Transport and Works Act 1992 (TWA): Application for the Rother Valley Railway (Bodiam to Robertsbridge Junction) Order

Proof of Evidence: Level Crossings and Land Accessibility

Philip Clark

Reference: TWA/18/APP/02/OBJ/1002/PJC/1

Figure 38: Water Main Utility

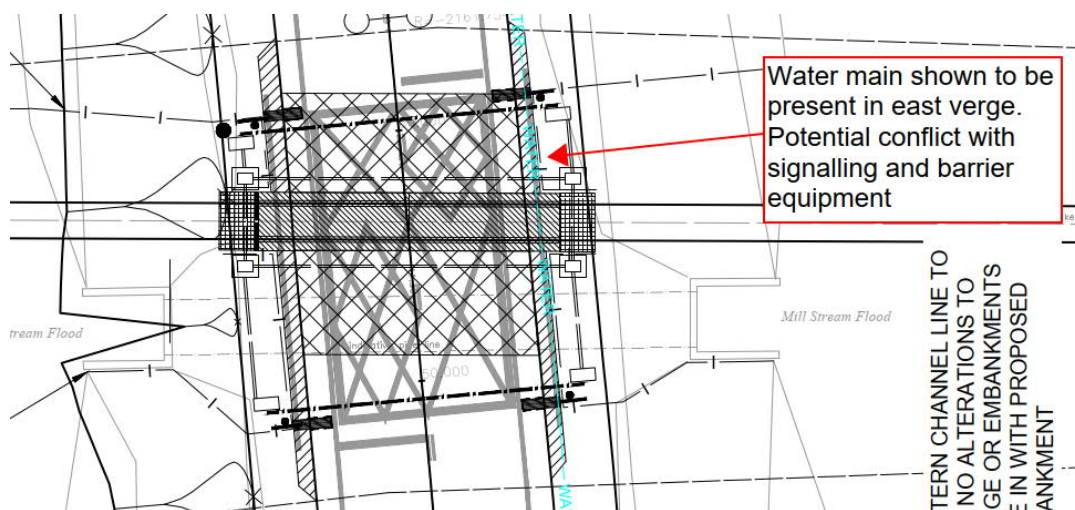
- 7.6.3. The associated level crossing general arrangement drawing 239025-ARP-XX-XX-DR-CH-0001 P1 does not show the water main.
